Marvel-Schebler/Tillotson

SERVICE BULLETIN

#A1-79

SUBJECT: HA-6 Aircraft Carburetor Part No. A10-5206-1

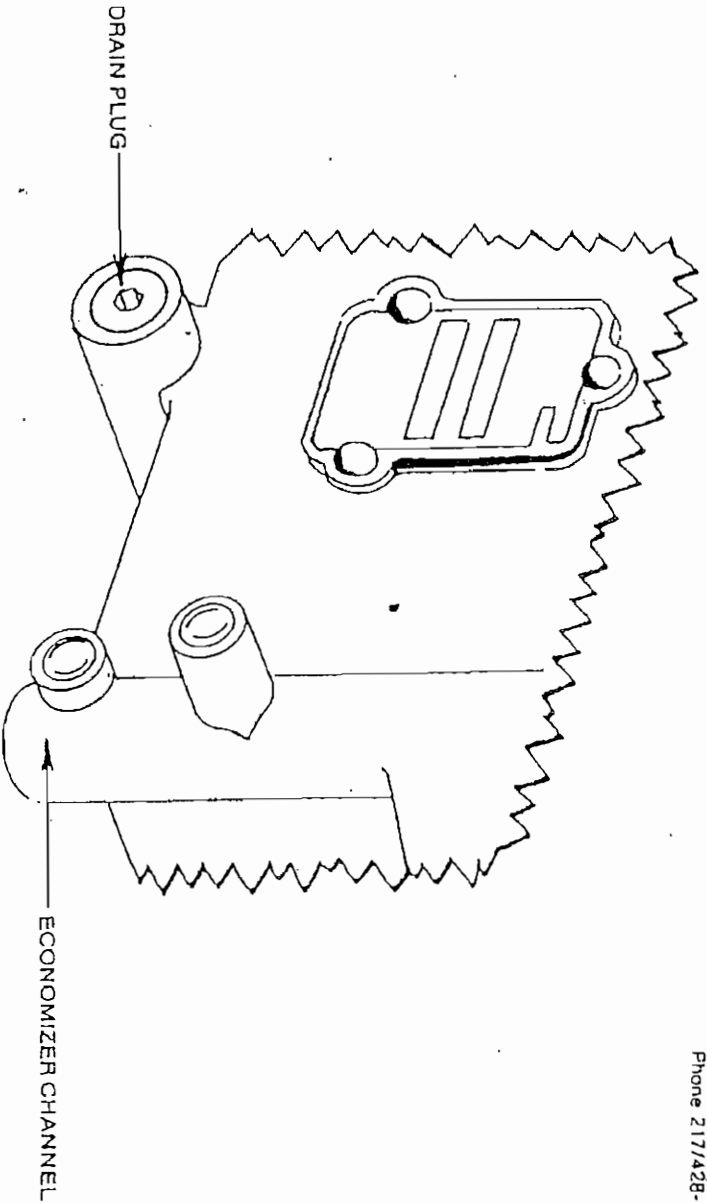
To improve the sealing of the internal economizer channel, remove the economizer channel plug #80-150 and replace it with #80-364 brass plug.

This can be installed with the carburetor on the airplane.

Kit #666-821 contains all necessary parts to service two carburetors as this installation is on a Beechcraft Duchess. Complete instructions on reverse side.
